**DEVELOPMENT CONSENT AUTHORITY
DARWIN DIVISION**

AGENDA ITEM: **1** **MEETING DATE:** 18 September 2026 **FILE:** PA2026/0269

APPLICATION PURPOSE:	Rooming Accommodation (Student Accommodation) with 40 beds and office in a 3-storey building
SUBJECT SITE:	Lot 359 (22) Progress Dr, Nightcliff, Town of Nightcliff
ZONE:	C (Commercial)
SITE AREA:	1000m ²
APPLICANT	Sheridan Consulting Director – Joseph Sheridan
PERSONS ON WHOSE BEHALF THE APPLICATION IS MADE	Ashford Architects Randal Ashford
LANDOWNER	David Superannuation Funds Pty Ltd as trustee for the David Family Superannuation Fund - Director Ronald David
ANY PERSON WITH AN AGREEMENT TO ACQUIRE AN INTEREST IN THE LAND	N/A

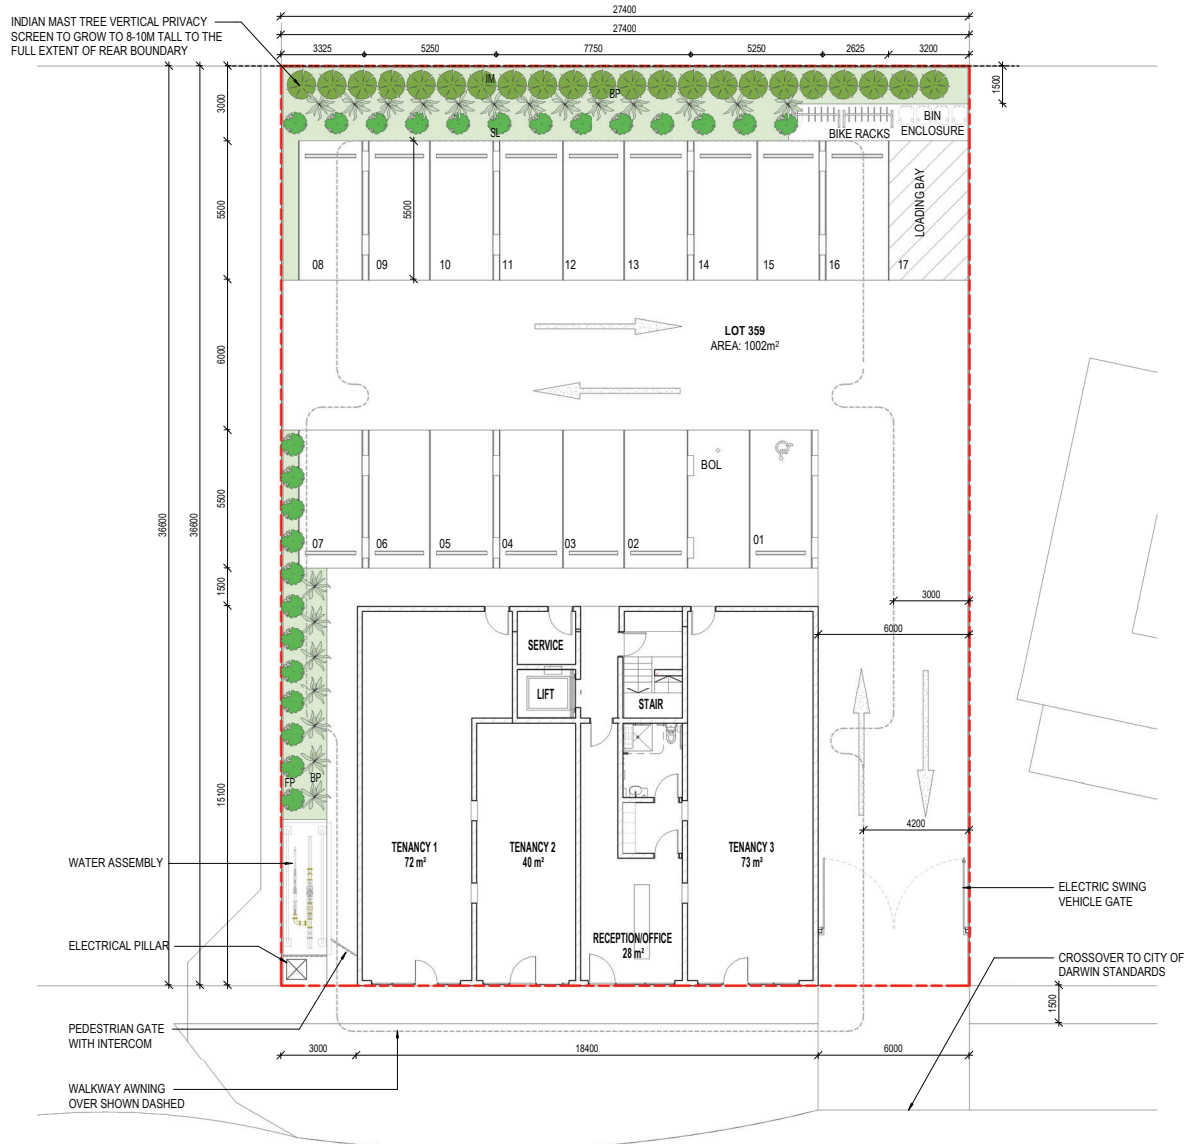
Sub-clause 3 requires that the setback (5m for non-residential use) described in sub-clause 2 is to be landscaped to provide a visual screen to the adjacent land Zoned LR for a minimum depth of 3m.

- The most sensitive interfaces are the northern and eastern boundaries adjoining Zone LR. The building retains setbacks of 3.8m to the north and 4m to the east, together with a 1.8m high solid screen fence along both boundaries. Landscaping and screening vegetation are provided along the northern interface, including Indian Mast Trees intended to provide additional vertical screening. The eastern roofline exceeds the required setback at 5.6m, increasing separation at the upper level. These measures, together with the articulated building form and balcony planting, assist in reducing overlooking, perceived bulk and visual impact on adjoining residential properties. To the west, the adjoining land is within Zone C and is currently occupied by a service station. The reduced setbacks associated with the balconies and awning therefore interface with an established commercial use rather than a sensitive residential use. As the principal building wall also achieves the required 3m setback, the western setback variations are not expected to result in an unreasonable amenity impact on the adjoining property.

GROUND FLOOR - GENERAL ARRANGEMENT PLAN
1: 100 @ A1

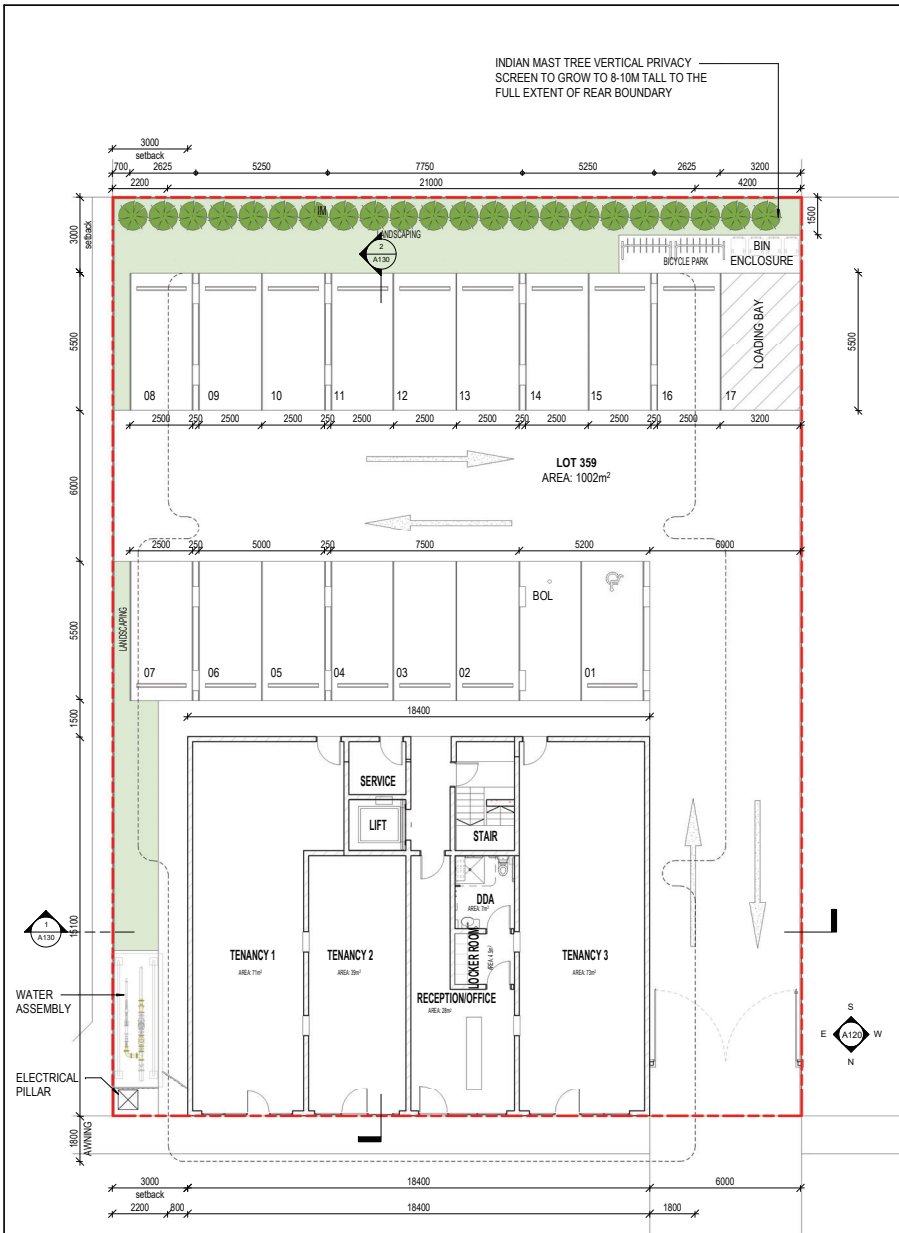
Further, sub-clause 9(a) requires *car parking areas are to have driveways with a minimum width of 6m for two-way traffic flow or 3.5m for one-way traffic flow*, where a single two-way access is provided from Progress Drive and the plans show a 6m distance between the building line and eastern boundary. However, the inward-opening electric swing gate is located within this area and projects into the driveway when open, meaning a clear 6m width is not maintained at the gate. Accordingly, the application does not comply with sub-clauses 8(d) and 9(a).

The application provides one loading bay to service the 185m² office component. The loading bay is approximately 3.2m × 5.5m, which is below the minimum dimensions of 3.5m × 7.5m required by sub-clause 4(b). While the loading bay itself is intended to provide the required height, access to it is via the eastern driveway beneath the Level 1 building projection, where the available vertical clearance reduces to approximately 3.2m, below the 4m required by sub-clause 4(c). The reduced clearance also affects the adequacy of access under sub-clause 4(d).

The proposal provides 28 bicycle parking spaces, substantially exceeding the minimum requirement of 15 spaces. However, the bicycle racks are currently located in the north-eastern corner, west of the bin closer and behind parking bays 15 and 16, with no separate cyclist access. When these parking spaces are occupied, direct access to the bicycle racks may be obstructed. The racks are also not shown as weather protected. Furthermore, in accordance with subclause 4, minimum 15 lockers would be required. The proposal provides 5 lockers adjacent to the ground-floor accessible shower/change facility, resulting in a numerical shortfall of 10 lockers.

Sub-clause 6 requires *buildings are to provide awnings for the length of the primary building frontage to a minimum of 3m wide*, where the awning along the Progress Drive frontage is 1.8m wide.

1. Prior to the endorsement of plans and prior to commencement of works, amended plans to the satisfaction of the consent authority must be submitted to and approved by the consent authority;
 - a) Showing clear, unobstructed access to the bicycle racks, which are to be located in a convenient and safe location with adequate security.
2. Prior to the endorsement of plans and prior to the commencement of works (including site preparation), in principle approval is required for the crossover and driveway to the site from the City of Darwin road reserve, to the satisfaction of the consent authority.
3. Prior to the endorsement of plans and prior to the commencement of works (including site preparation), approval is required for the awnings to the three street frontages to the requirements of the City of Darwin and Power and Water Corporation, to the satisfaction of the consent authority.
